May 25, 1990

Subject: High Pressure Injection/Makeup Nozzle and Thermal Sleeve Program  
Davis-Besse Nuclear Power Station Unit 1

May 10, 1990 Meeting on HPI Nozzle Inspection

# HPI/MAKEUP NOZZLE PROGRAM

CRACK SIZE  
CRITICAL CRACK SIZE EVALUATION  
APPLIED VERSUS ALLOWABLE STRESS INTENSITY  
FOR SECTION A-A

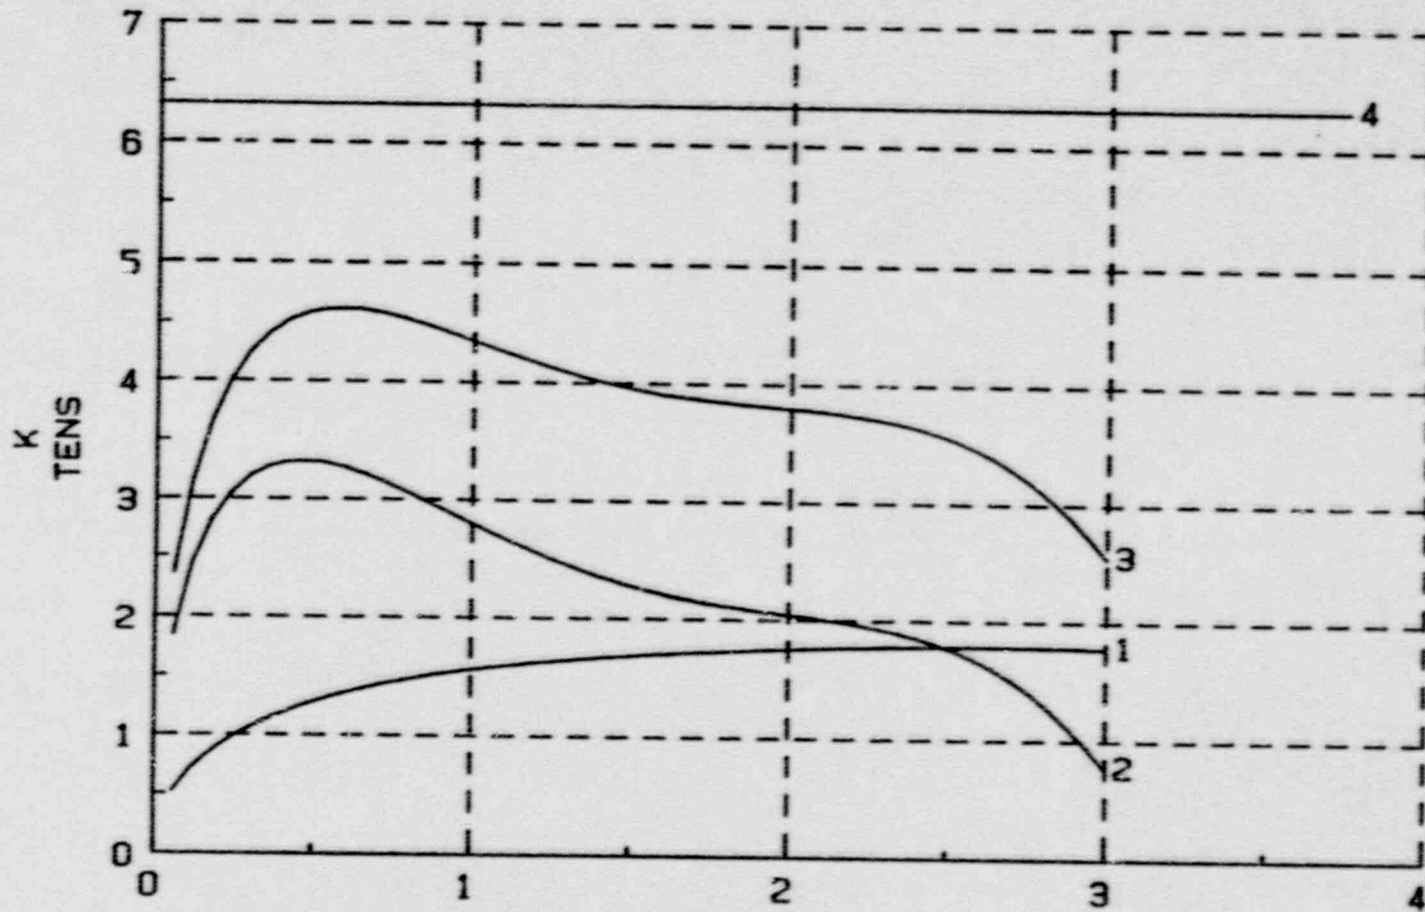
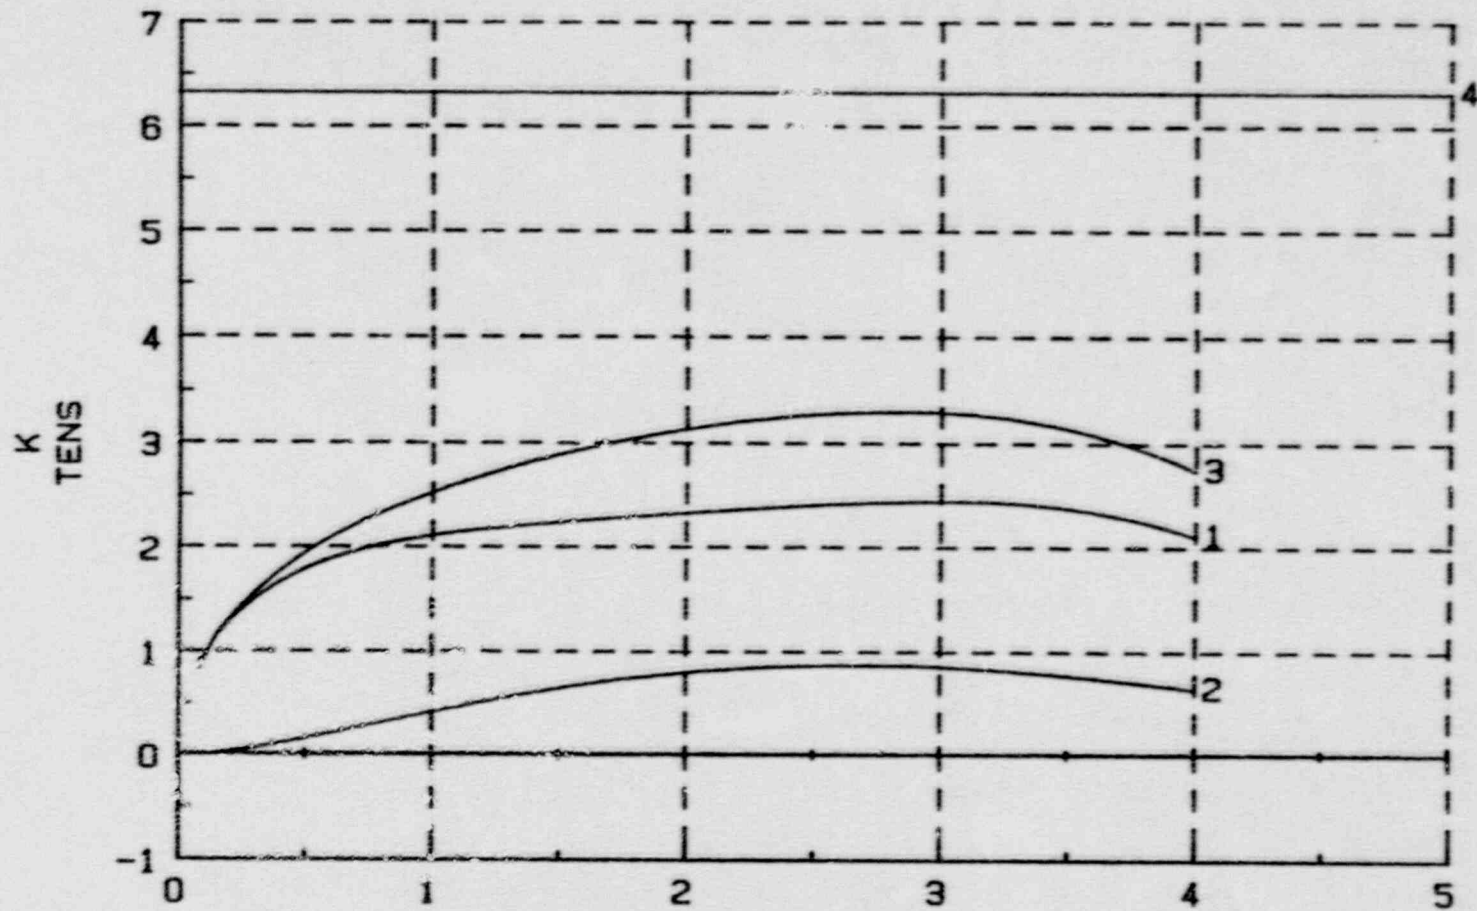
At the May 10, 1990 meeting, the Staff questioned the degree of conservatism afforded by the **pc-CRACK** nozzle corner flaw model. The Staff suggested augmenting the analysis by using a crack emanating radially from a hole in an infinite plate model which is more conservative than the **pc-CRACK** corner flaw model, but is more representative of the configuration than the SECP model. The staff indicated that the use of this model would provide adequate additional assurance of nozzle integrity.

Toledo Edison believes that the **pc-CRACK** corner flaw model most accurately represents the nozzle configuration, is experimentally validated and is appropriately conservative. However, Toledo Edison will perform an additional analysis to provide information on the sensitivity of the results to a more conservative model. The configuration will be modeled as a crack emanating radially from a hole in an infinite plate. The results of this additional analysis will be submitted to the NRC approximately two months after restart from the 6RFO.
